TRANSPORT TECHNICAL NOTE

To: **West Sussex County Council / National Highways**
From: **Iceni Projects Ltd**
Date: **April 2026**
Title: **Reeds Lane, Sayers Common**

1. Iceni Projects Ltd (IPL) has been instructed by Reside Developments to provide transportation advice regarding their development proposals at Reeds Lane, Sayers Common (the Site). A planning application was submitted to West Sussex County Council (WSCC) in December 2025 (ref: **DM/25/3067**) for the following:

National Highways Planning Response (NHPR 25-01) Formal Recommendation to an Application for Planning Permission

TACTILE PAVING ALONG B2118/OAKHURST JUNCTION (VIEWPORT 1)

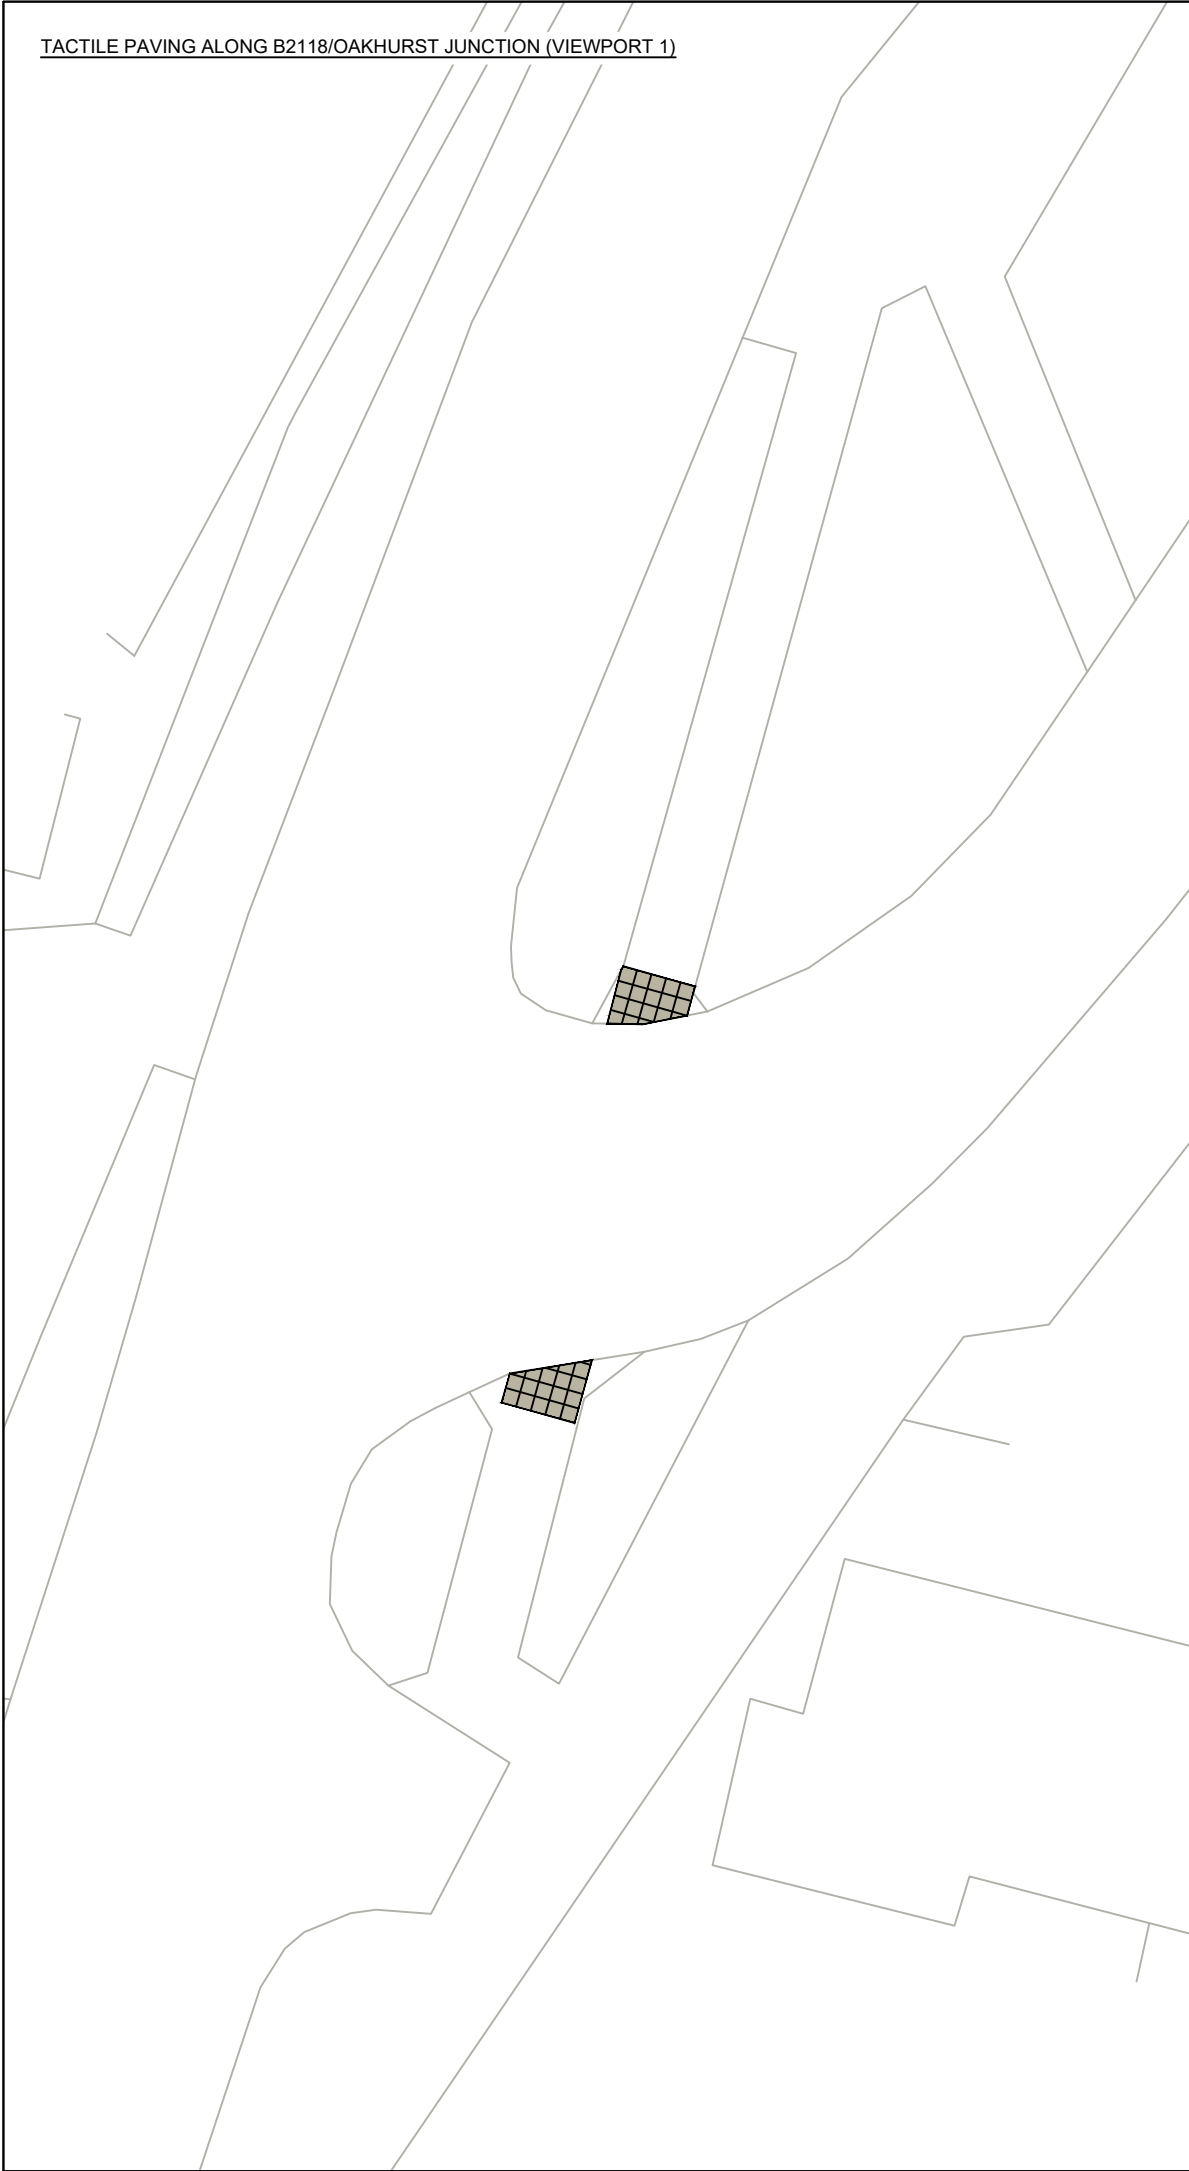
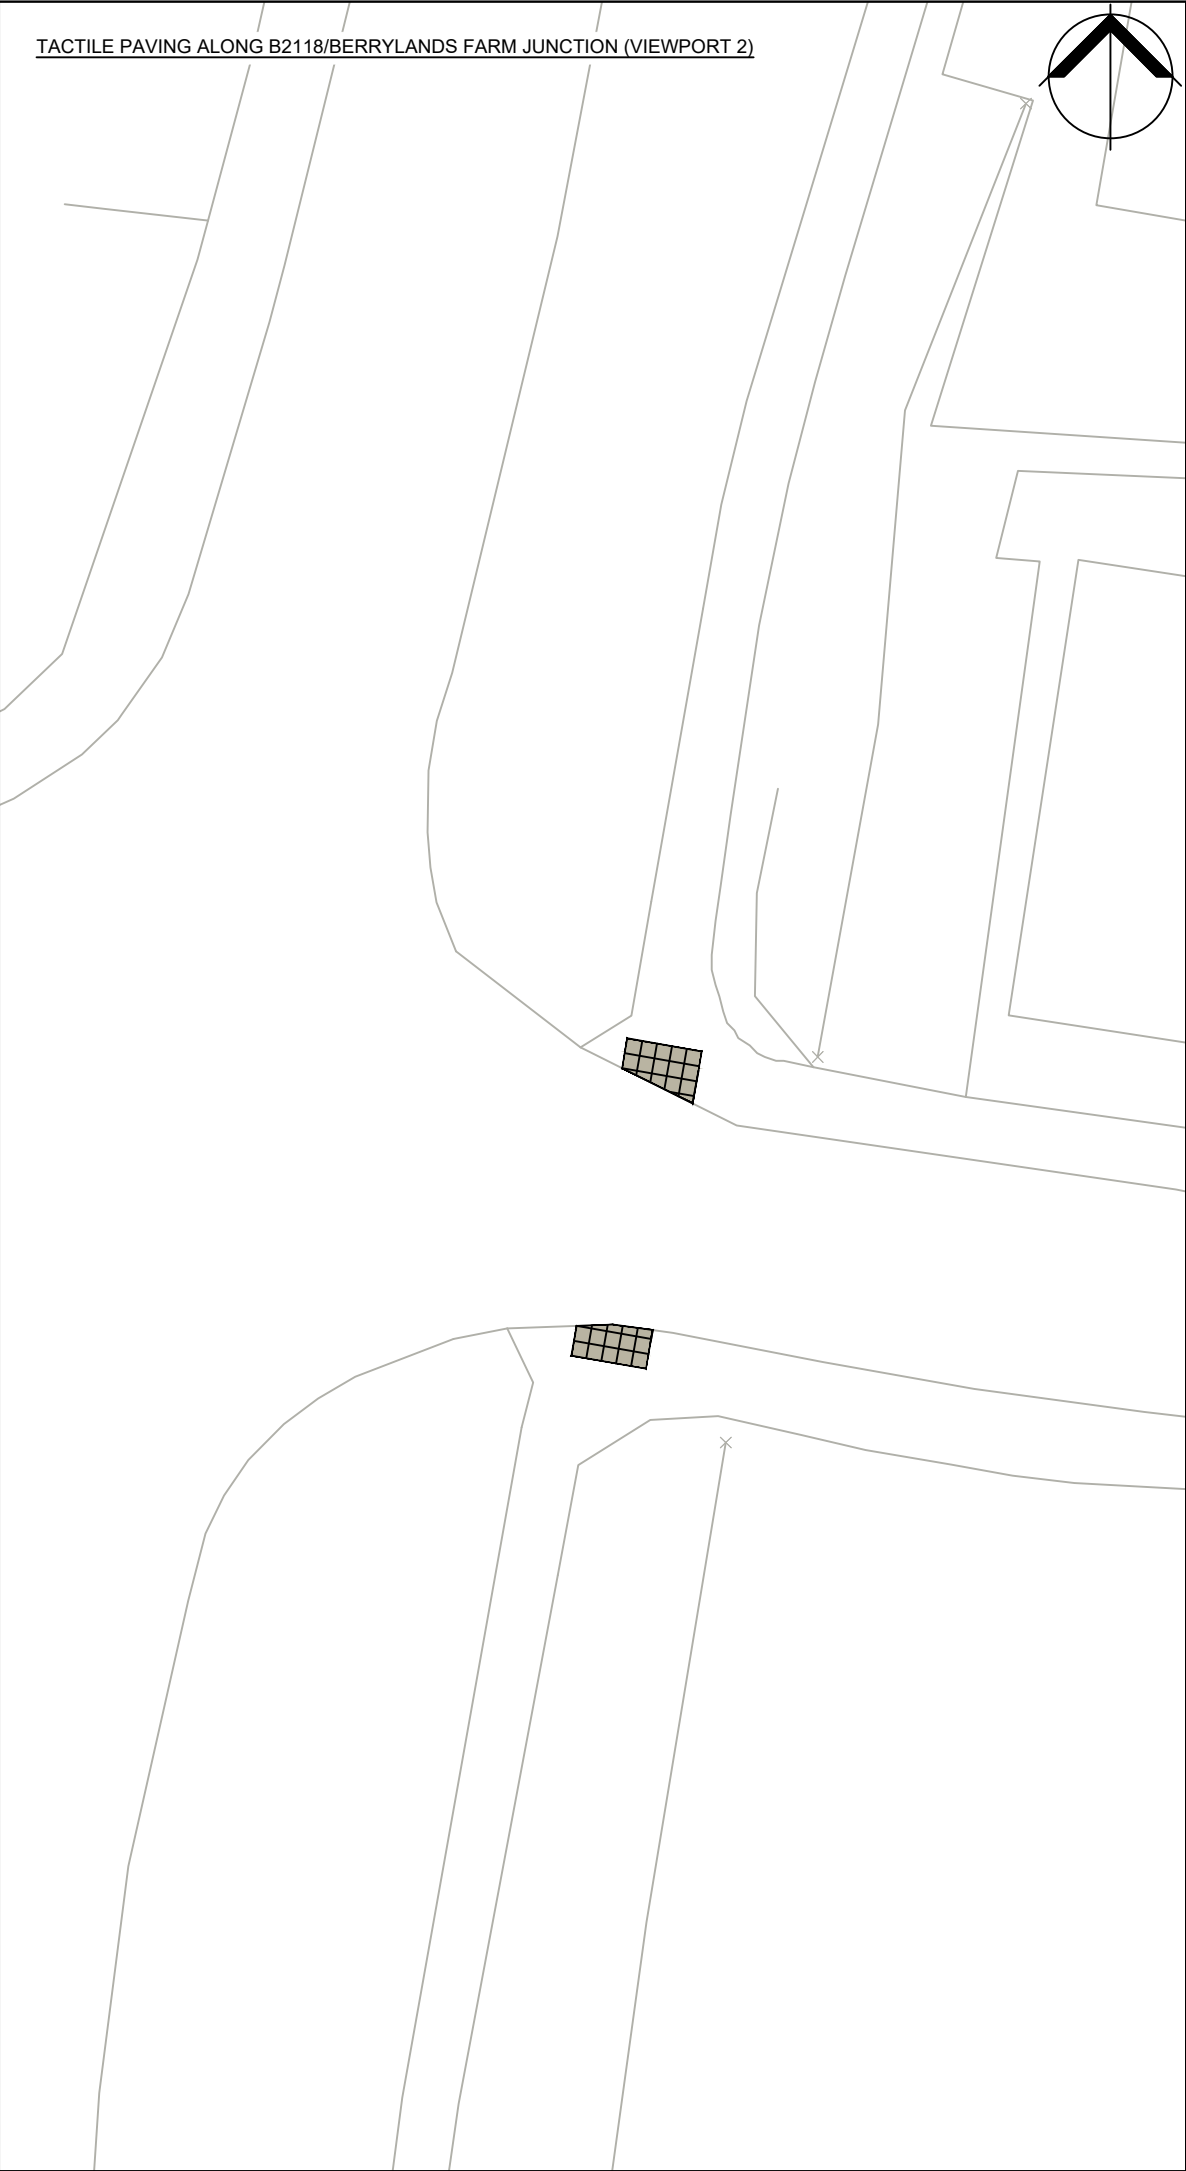
Provide drawing detailing tactile paving to the existing dropped kerbs of Oakhurst and Berrylands Farm side road crossings to ensure improvements are secured regardless of whether DM/25/1434 is permitted/comes forward first.

31. **Drawing I002003_06** is provided at **Appendix A4** showing tactile paving at the existing dropped kerbs of Oakhurst and Berrylands Farm side road crossings.
